SHOP DRAWING TRANSMITTAL

Project:	Turnbull School Room Addition	Music	Project No:	1705
	Date:	November 9, 20	18	•	
\bot	To:	TALCO Building Innovations Ltd.			
	Attn:	Farah Bano (fba	ano@tal-co.com)		
HOBIN	From:	Michelle Cataldo			
ARCHITECTURE	☐ Approval ☐ Distribution ☐ Information and ☐ Review and Com ☐ Other		☐ Courier☐ By Hand☐ Fax☐ To Be P☐ €-mail	d icked Up	
Partners					
Barry J. Hobin OAA, FRAIC, Hon. Fellow AIA	Shop Drawing Sub	omittal:	Division 22 – Plur	nbing Fixtures	8
William A. Davis OAA, MRAIC, Associate AIA	Submitted by:		S&R Mechanical		
Gordon Lorimer OAA, FRAIC, Associate AIA	Drawing Title:		Sink Faucet Spec	Sheet	
Wendy Brawley	Revision No.		N/A		
OAA, MRAIC, Associate AIA Douglas Brooks	Dated:		Oct. 17, 2018		
Senior Arch. Tech.					
	Comments:				
Directors					
Marc Thivierge OAA, MRAIC	Reviewed.

Project: Turnbull Music Rm Addition

Mech Shop Drawing Review Comments

BAR & PREP SINK FAUCETS

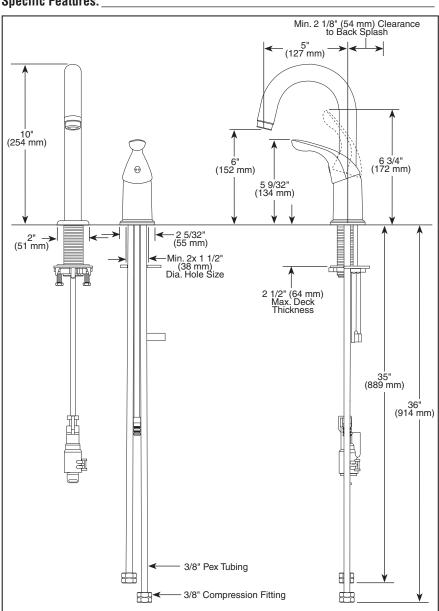
Item	Description	Submitted File	Comments
2.1	Sink Faucet	22 Faucet SD.pdf	Reviewed
